LAND AT LITTLE TARRINGTON, HEREFORDSHIRE

RESPONSE TO LLFA COMMENTS

DRY BASIN CROSS SECTION NOT TO SCALE

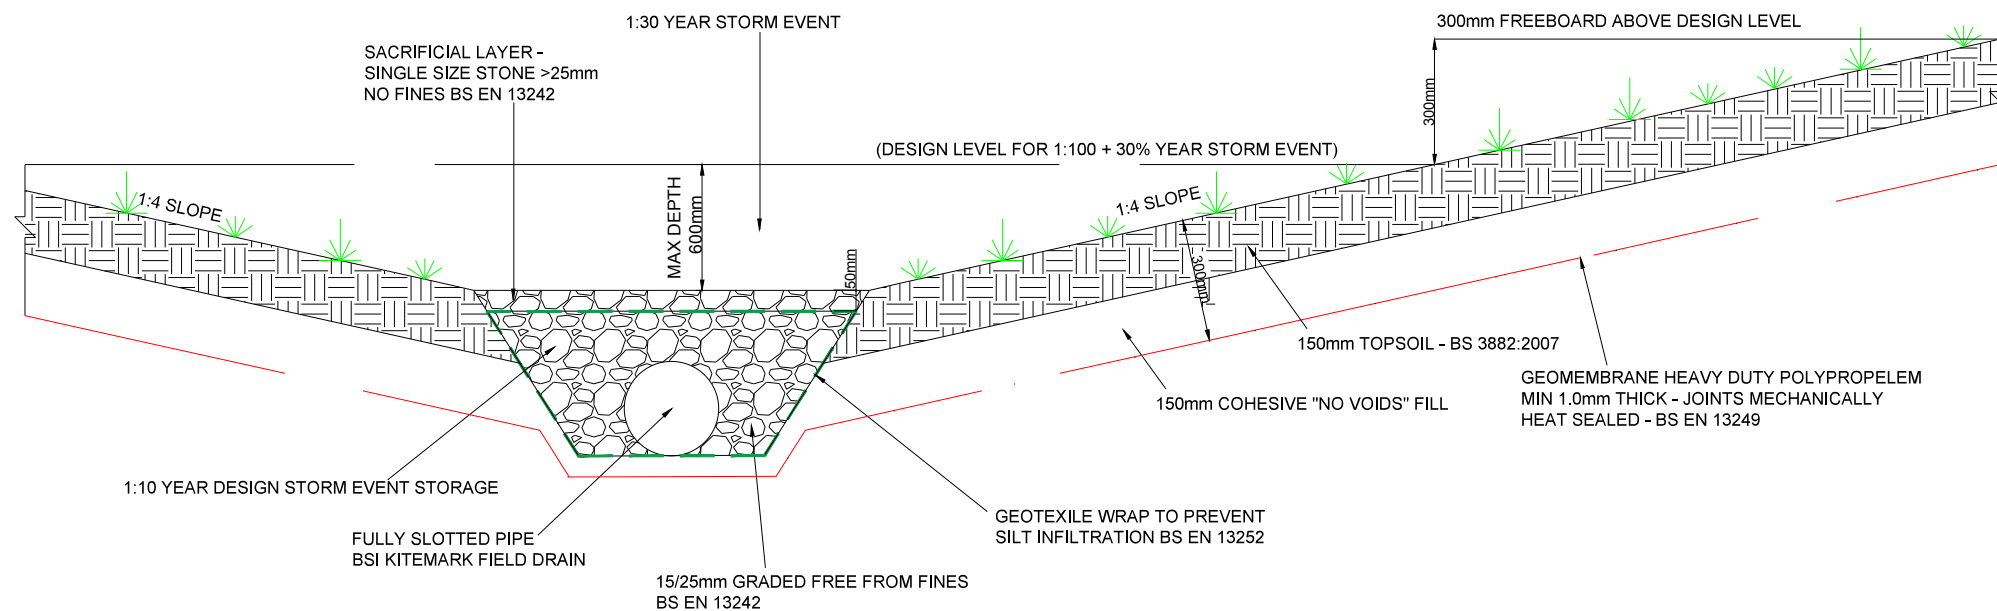
We can also consider for adoption the detention basin feature for which you have the indicative drawings. This is a dry feature which would be acceptable in an off-line arrangement. The perforated pipe, laid in backfill and surrounded by a membrane to prevent groundwater ingress, would constitute a sewer. For smaller storm events (say 1:10yr or 1:30yr) the perforated pipe and volume below ground would be utilised, with the detention basin storage area above being utilised for larger storm events. One of the advantages with this arrangement is we would accept the 1:100yr storm event storage in this adoptable feature, whereas generally the adoptable system should only be designed to cater for the 1:30yr storm event as per SFA7.

- 4.2. The proposed detention basin has been designed based on the indicative drawings provided by DCWW. The design of the proposed detention basin is explained in paragraphs 3.25 – 3.31 of the Discharge of Conditions report which supported the application (report reference: B731-DOC01-Discharge of Conditions, Issue 1, December 2019).
- 4.3. It is therefore considered that the proposed detention basin is suitable for adoption by DCWW under S104 of the Water Industry Act 1991. The S104 adoption process can only be progressed once planning permission is granted. As such the assurance provided by DCWW regarding the principles of the detention basin adoption should be sufficient to discharge condition 16 of the outline planning application.
